RFIs - 36C25626R0006 - Med Gas Deficiencies
598-23-107

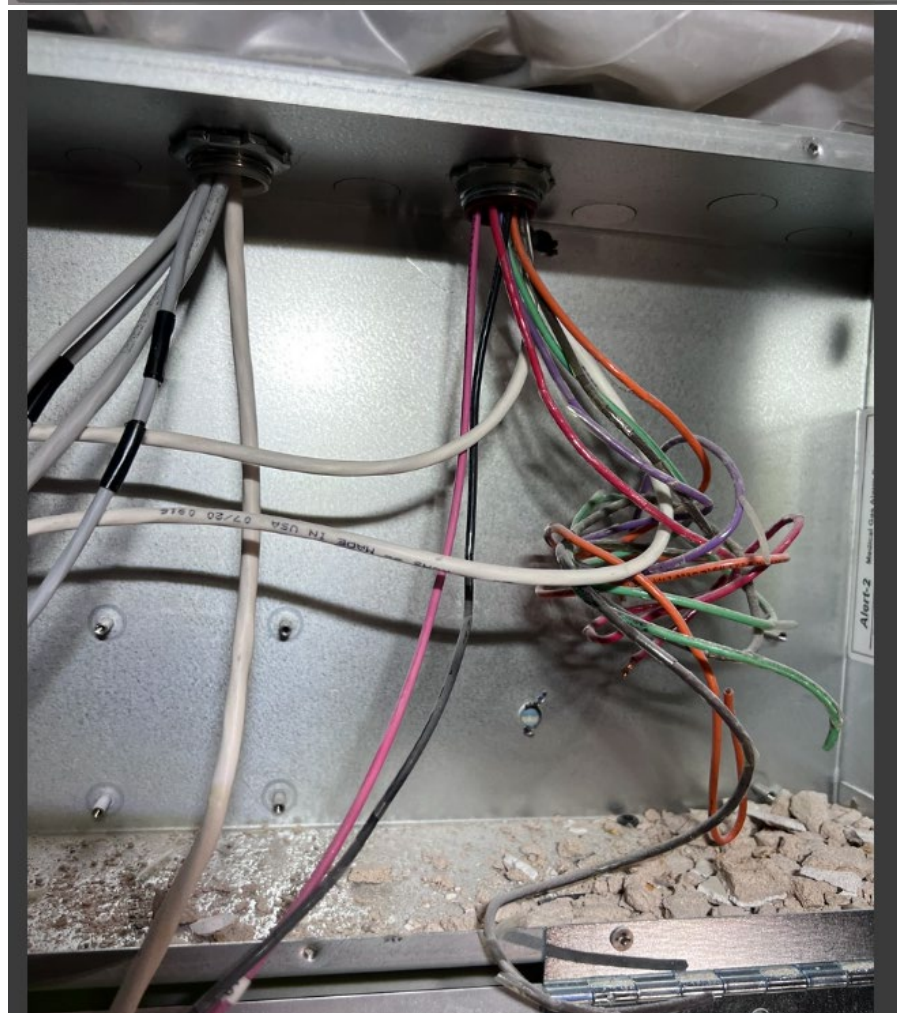
19. Will the VA confirm whether service/zone valves exist at each floor or within critical care areas at JLM Hospital to allow backfeeding during the temporary shutdown for valve replacement? IF SO identify where service/zone valves currently exist.

Response: Yes, the valves are located in hallway of each POD.

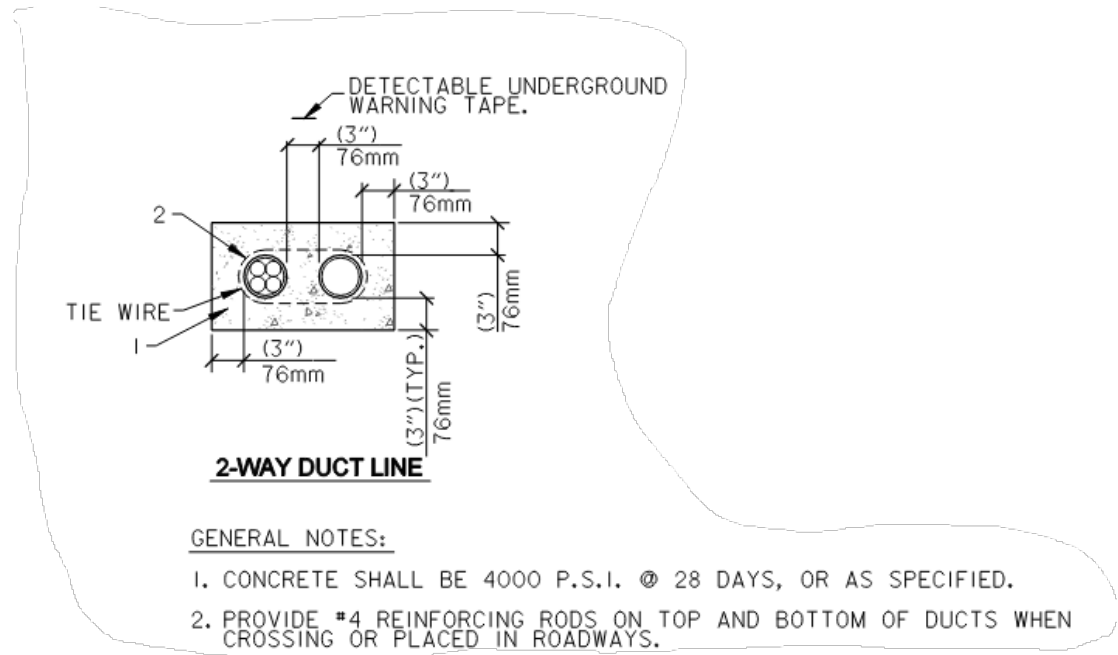
48. Installation of the communication duct bank as shown on Drawing CU100 would require relocation of the existing chiller, which would impact hospital operations. Will the VA confirm whether installation beneath the chiller is acceptable, and if so, provide the required minimum clearance, depth, encasement requirements, and acceptable excavation methods (e.g., hydrovac)?

Response: The chiller is a temporary unit. The unit is in that location between 04/01 – 10/30 each year.

12 CONDUIT WALL PENETRATION DETAIL
Scale: 3" = 1'-0"

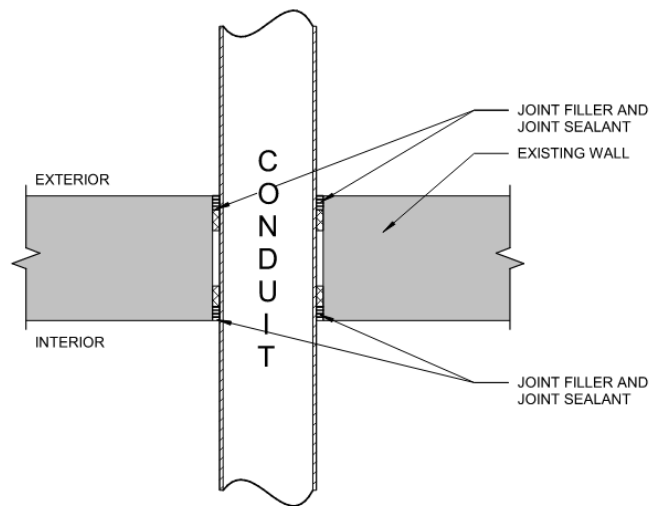
57. Drawing 001.T-100, Key Note 13. Please confirm the accepted waterproofing method/material, sleeve requirements, and firestopping expectations (if applicable) for communications conduit penetrations through exterior building walls.

Response: Please see specifications page 07 92 00-5 Part 2 Products 2.1 Sealants A. Exterior Sealants.
